SUPPLEMENTAL DESIGN NARRATIVE

EQUIPMENT LAYOUT
 OR #636
 OPTION #2
 SENECA HEALTHCARE DISTRICT
 TREATMENT ROOMS #1-5, ENDO #632, OR #636
 CHESTER, CALIFORNIA 96020

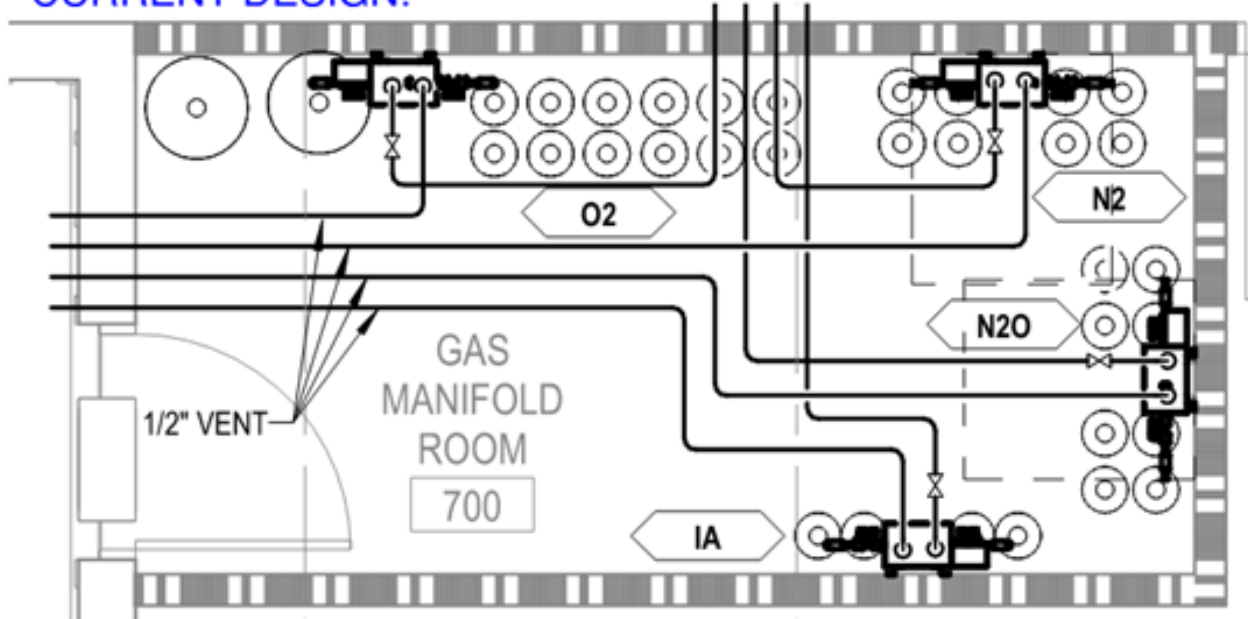
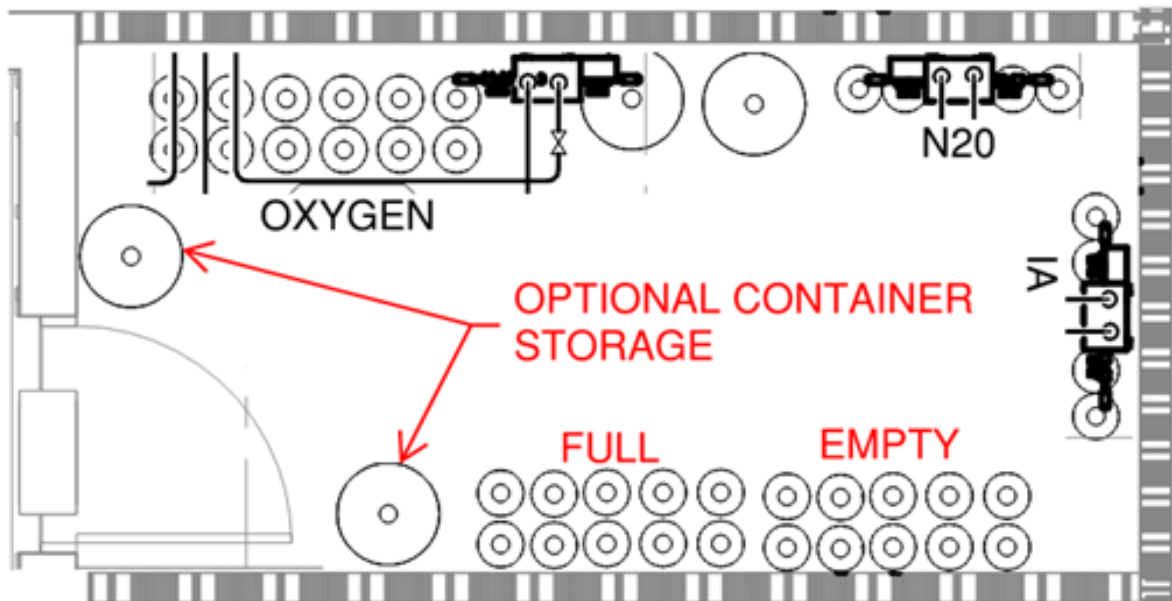
- A. Gas Manifold room layout: Revise room layout per sketch included within the narrative appendix
- B. Nitrogen gas: Remove the nitrogen gas manifold from room 700 and all associated piping routed to the ORs.

CURRENT DESIGN:

PROPOSED REVISION:

Item D - Endo and OR boom 3-boom layout

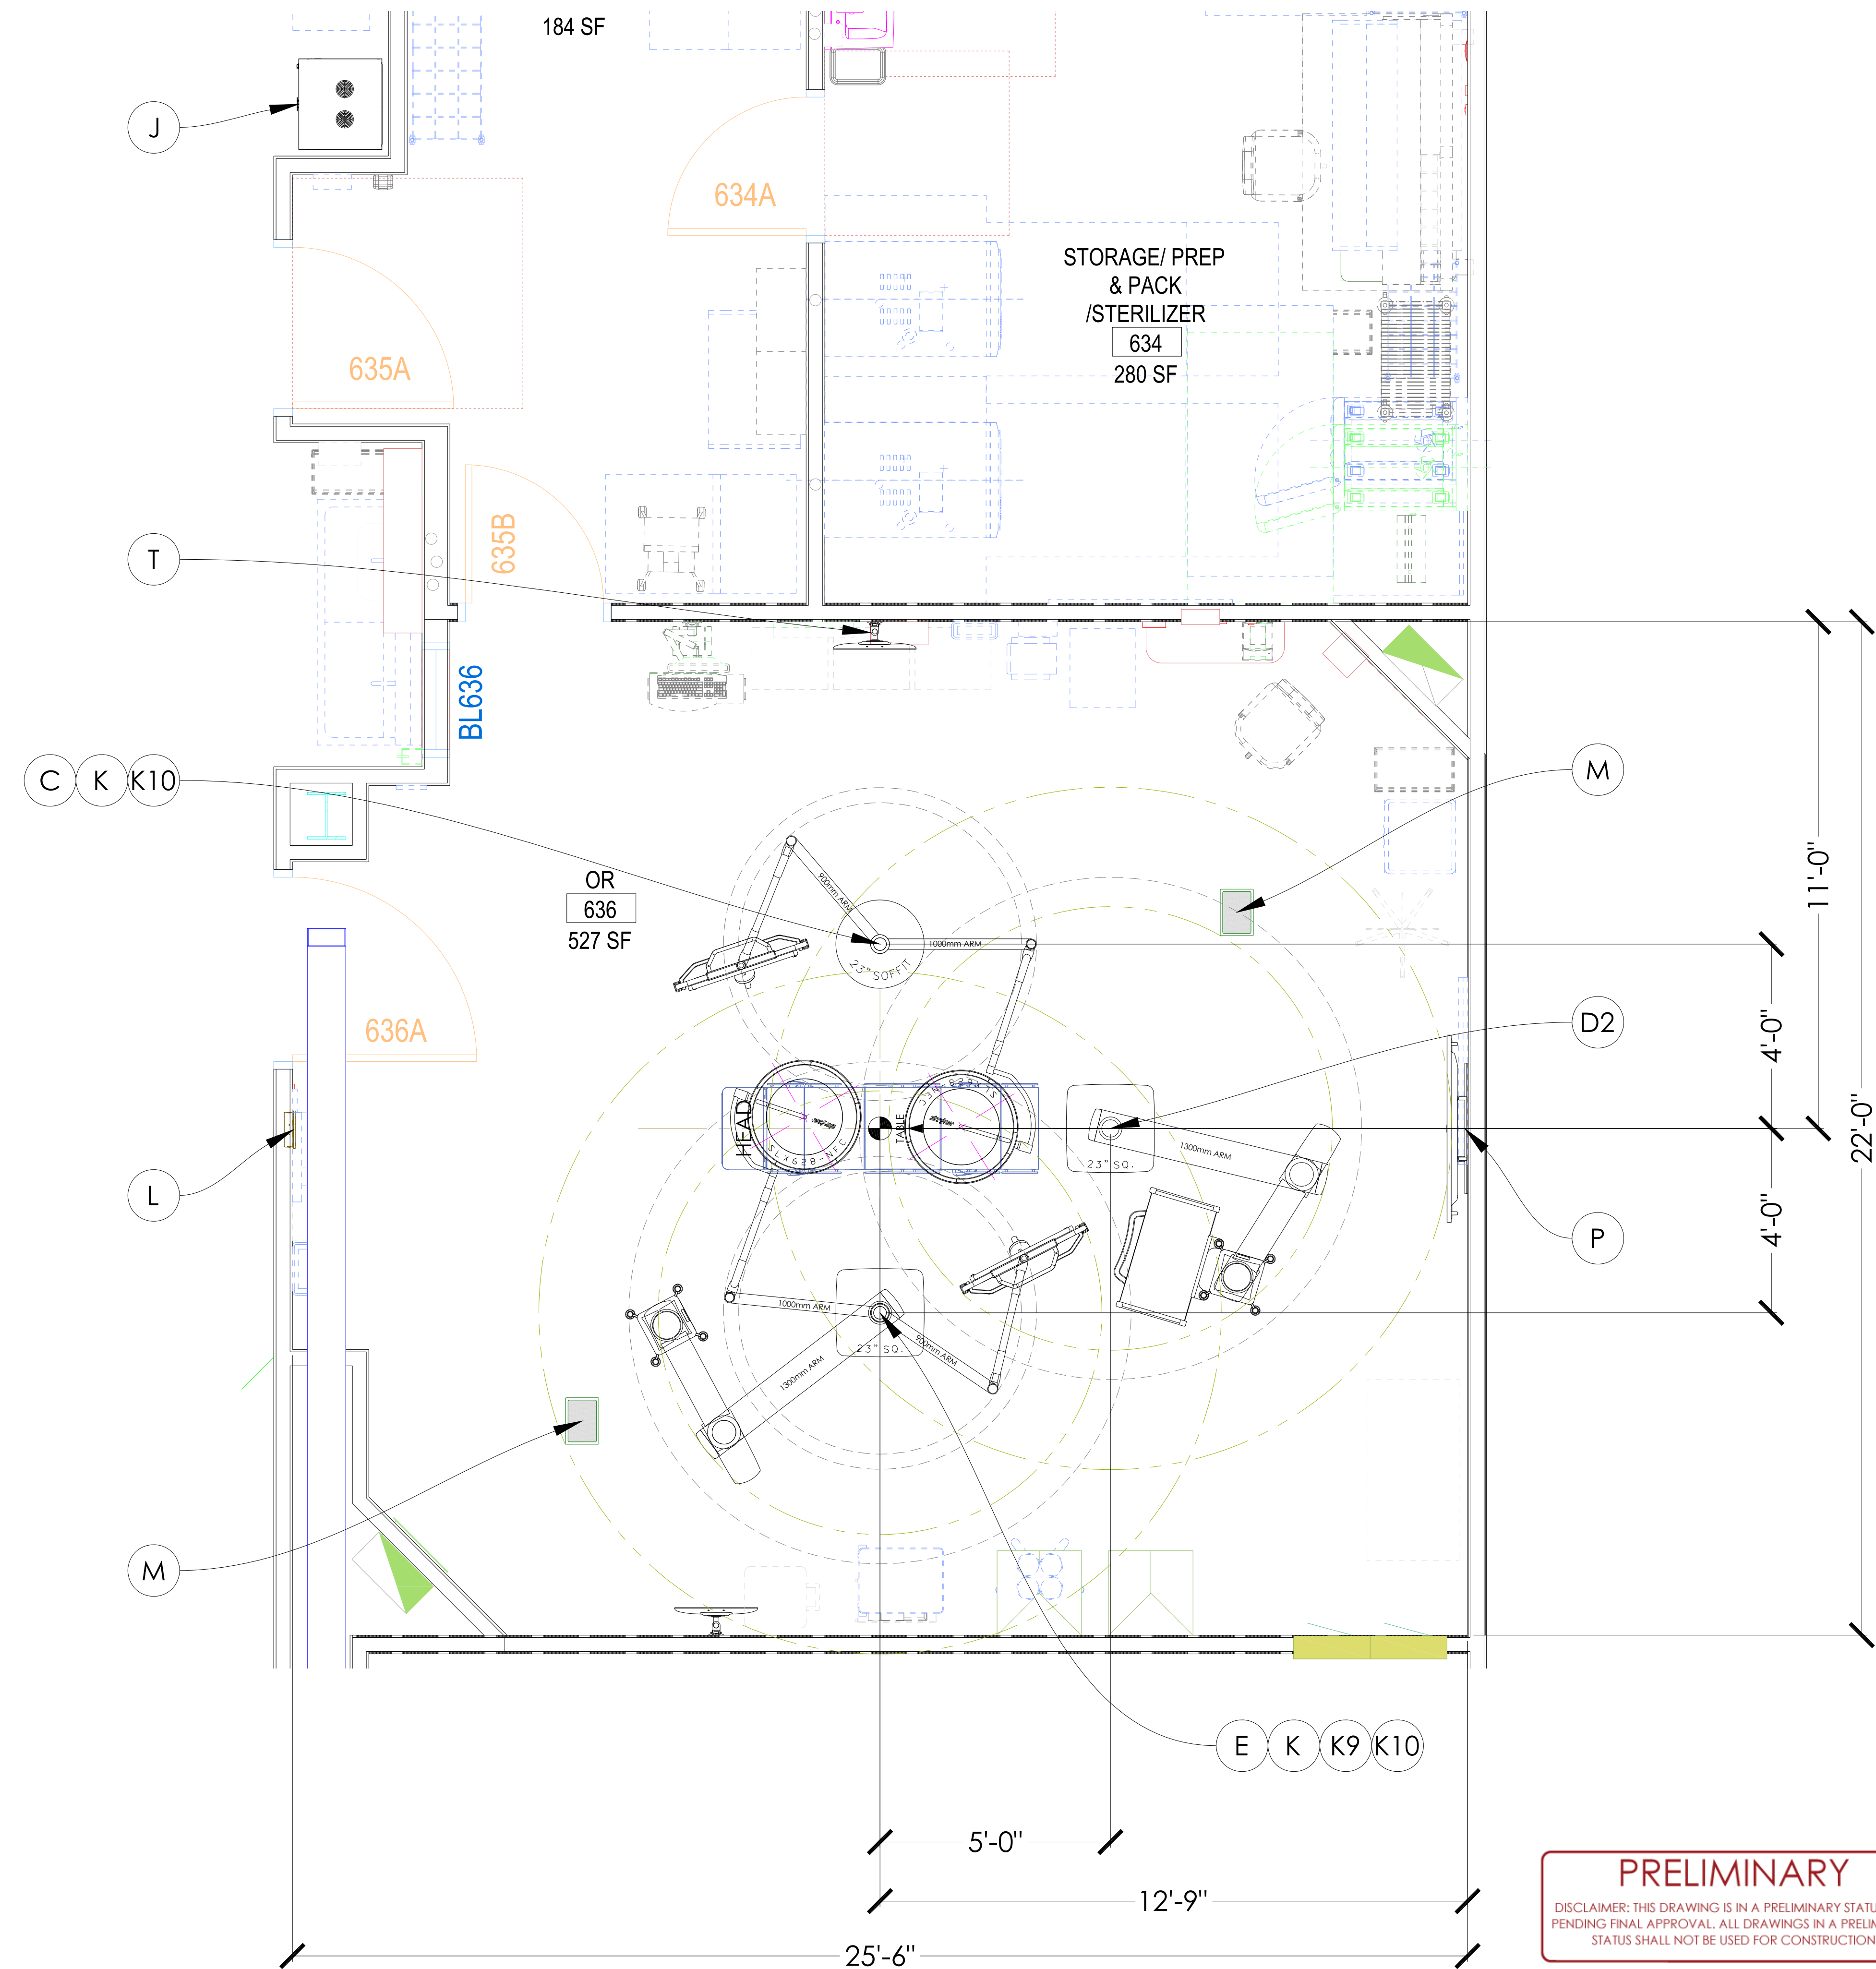
- A. Ice machine revision: The current specified ice machine is to be revised to the following product: Scotsman HID312A-1 Touch-free Ice machine/dispenser. Dimensions and MEP requirements remain similar/consistent with the original selection.
 - 1. <https://www.scotsman-ice.com/>
- B. Endo and OR boom number and orientation:
 - 1. Revise current boom orientation from E/W to a N/S orientation. Table location to remain as currently depicted.
 - 2. Provide Add alternate to include 3rd boom. See appendix for Stryker sketch.
 - a. North – lighting/monitor boom
 - b. East – Equipment boom
 - c. South – Anesthesia/lighting/monitor boom
